Modification Sheet No. HDSO/WAM4/75.

1. Title of modification :
Shifting of control supply to DC Coil of M/s English Electric make relays QRS I-1/2, QLM, Q 30 from CCLS to CCPT.
2. Application to Class of Locomotives :
WAM4 locomotive No. 20654 to 20676.

REF. WAM 111 SCALE 1/16" = 1" (1/16" = 1")
MODIFIED CONNECTIONS FOR TYPE
CLIM AND QRS RELAYS
REVISED DATE 11/1/54

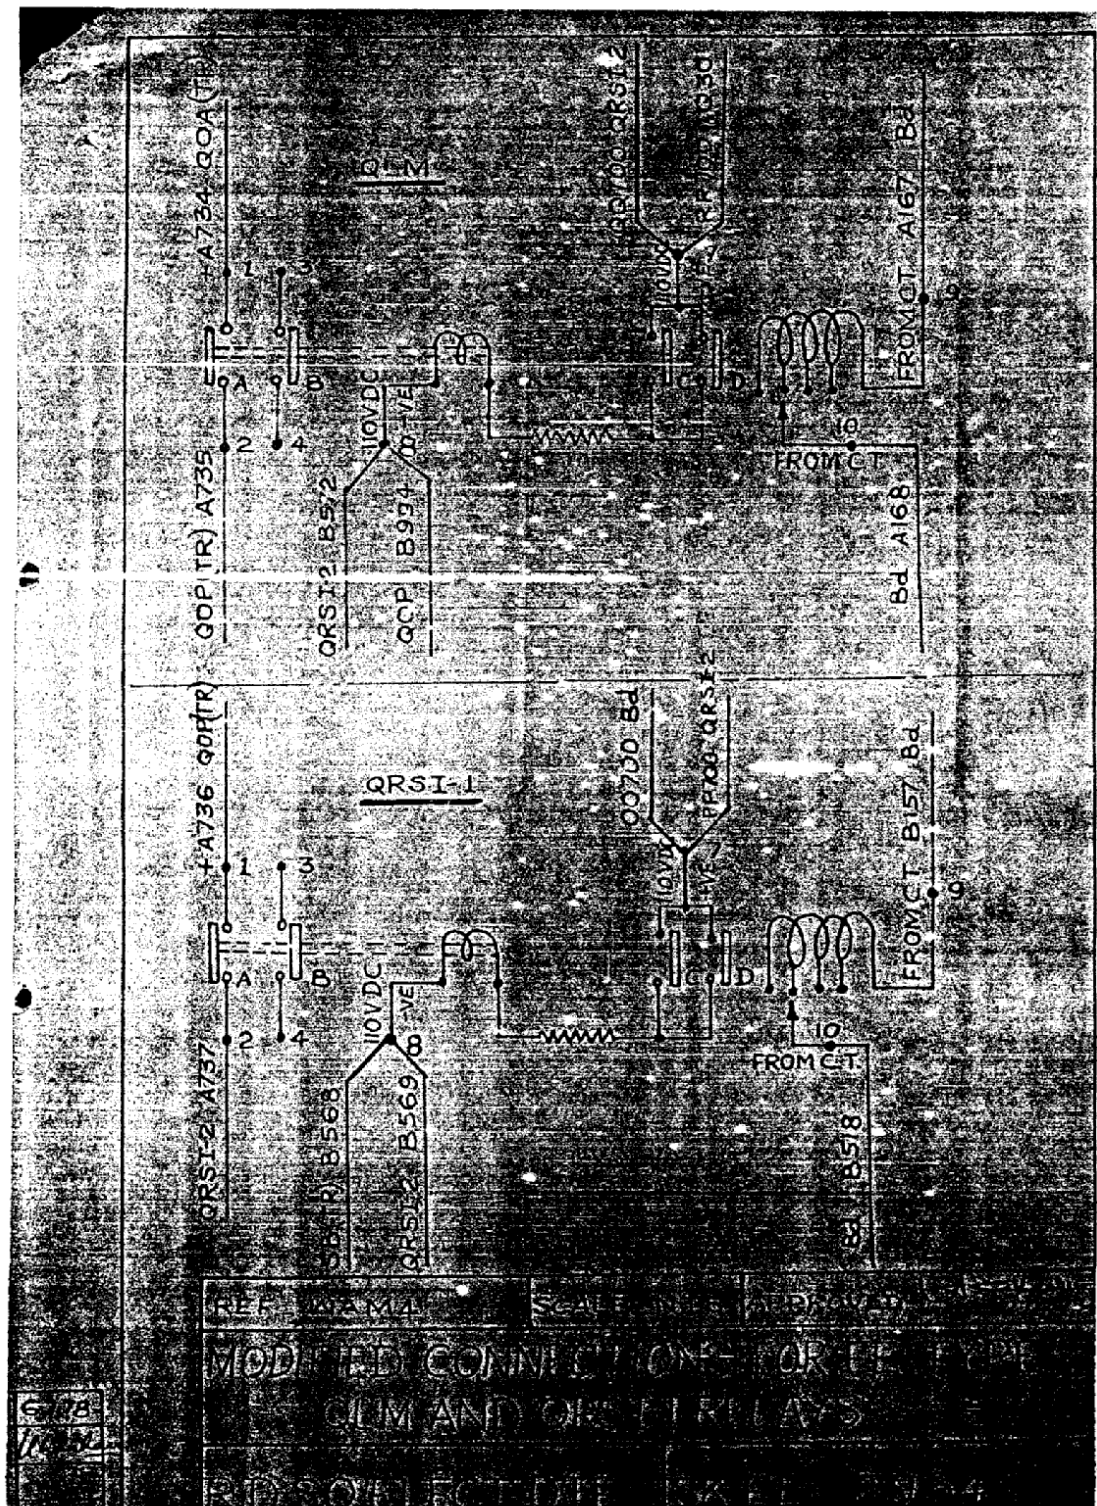
3. Object of Modifications :
Ghaziabad Shed reported frequent tripping of DJ in the event of melting of fuse CCLS due to short circuiting of Indication Lamps and other minor faults. The feed to DC Coil of M/s English Electric make relay used as QRSI. 1&2 QLM & Q30 is through CCLS fuse, thus melting of CCLS fuse (due to minor reasons) trips DJ. By shifting the feed of these relays to CCPT such trippings will be eliminated.

2.5 mm² cable of 750 V grade - 2.5 metres/Locomotive.
(b) Material rendered surplus :
Nil.
7. Work to be carried out :
 - i) Cable No. GG 211 from QV 60(N/O) to QRSI-1(term.7) to be disconnected at both ends.

- ii) Lay a new cable ⁰⁰⁻700 from BD 700 terminal to QRSI-2 terminal No.7.
 - iii) Change the existing tag HH211 as PP700 from QRSI-1 to QRSI-2 at both ends.

- iv) Change the existing tag II 211 as QQ 700 from QRSI-2 to QLM at both ends.
 - v) Change the existing tag NN 211 as RR 700 from QLM to Q 30 relay at both ends.
